Subject: Fw: S. 16 Planning Application No. A/YL-KTN/1250 - Departmental Comments

Ref.: S. 16 Planning Application No. A/YL-KTN/1250 - Departmental Comments

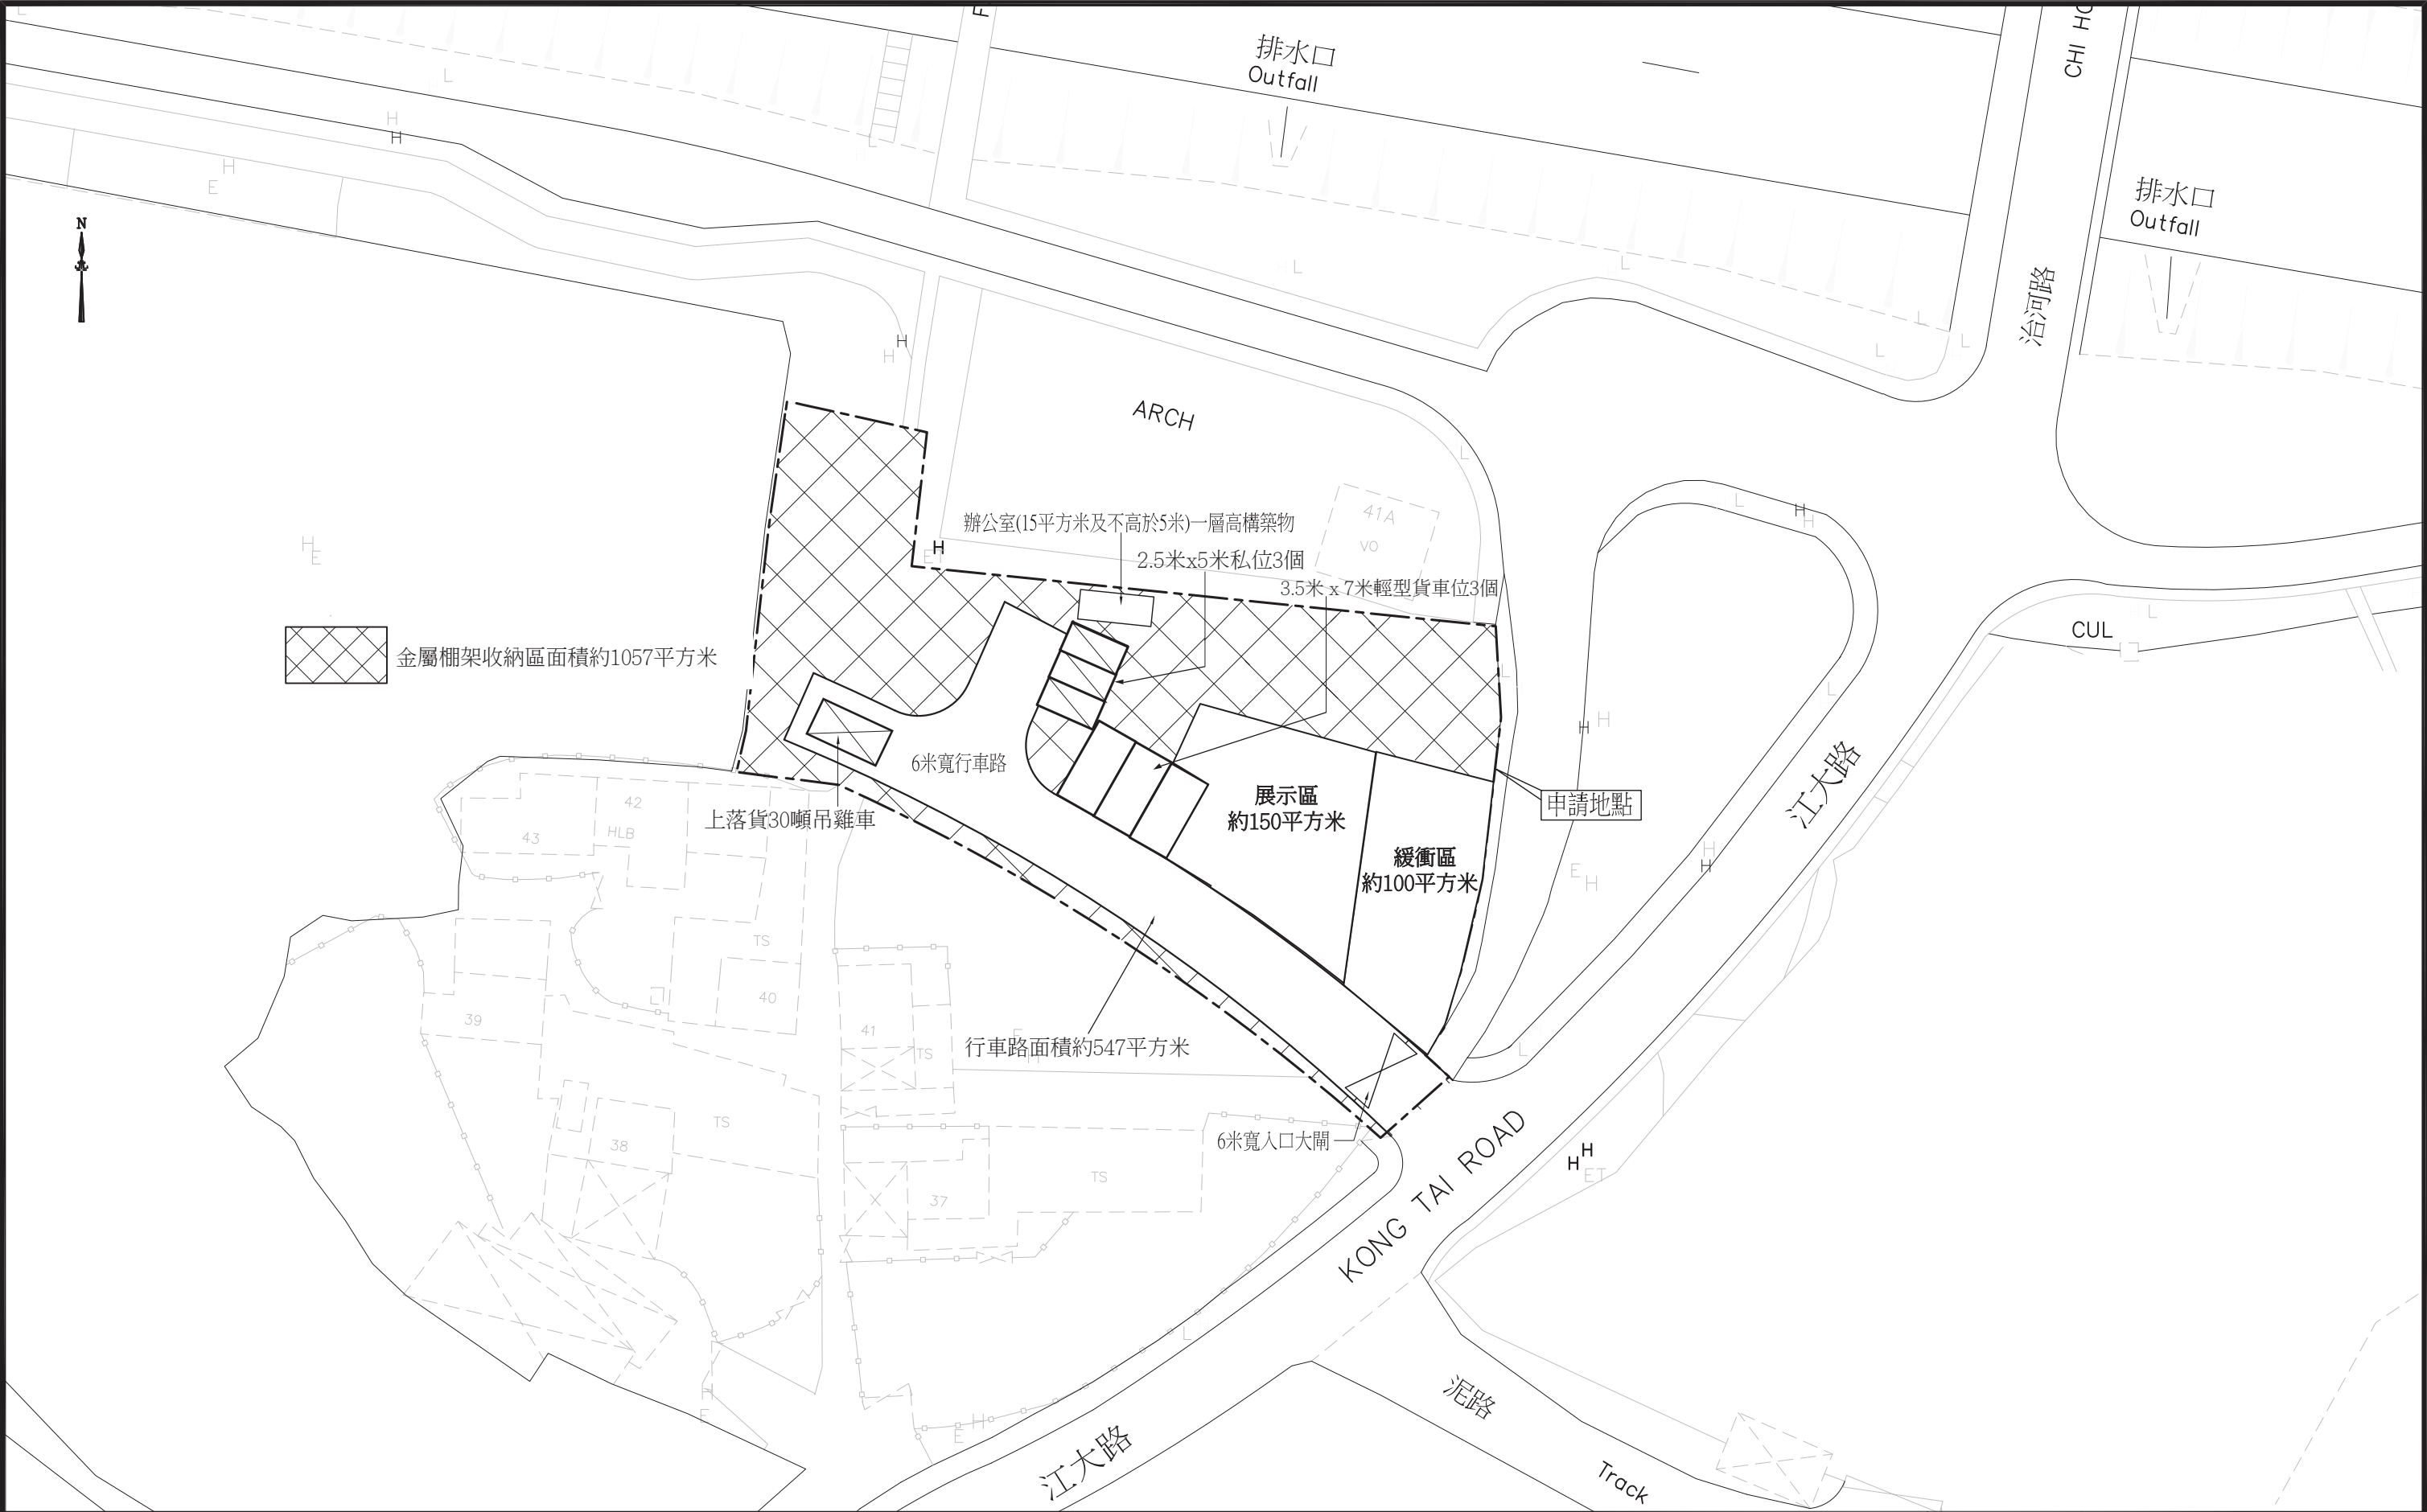
Existing water mains will be affected as shown on the Plan. The cost of any necessary diversion shall be borne by the proposed development.	申請人了解本申請有機會影響現有的供水設施，如需要配合更改供水設施，申請人可以提供一切幫助，包括同意水務署職員或其外判工程人員隨時進出本申請範圍，以便貴署進行供水相關的工程。
In case it is not feasible to divert the affected water mains, a waterworks reserve within 1.5 metres from the center line of the water main shall be provided to WSD. No structure shall be built or materials stored within this waterworks reserve. Free access shall be made available at all times for staff of the Director of Water Supplies or their contractor to carry out construction, inspection, operation, maintenance and repair works.	若遇上既存在而又未能更改該水喉或水掣位置，申請場地會預留與水掣的中心線不小於 1.5 米的空間，以便貴署進行相關的工程。
No trees or shrubs with penetrating roots may be planted within the Waterworks Reserve or in the vicinity of the water main shown on the plan.	此申請範圍內不會進行栽種任何含有入侵式根部的樹木 (Tree or shrubs with penetrating roots)，以免影響供水設施。
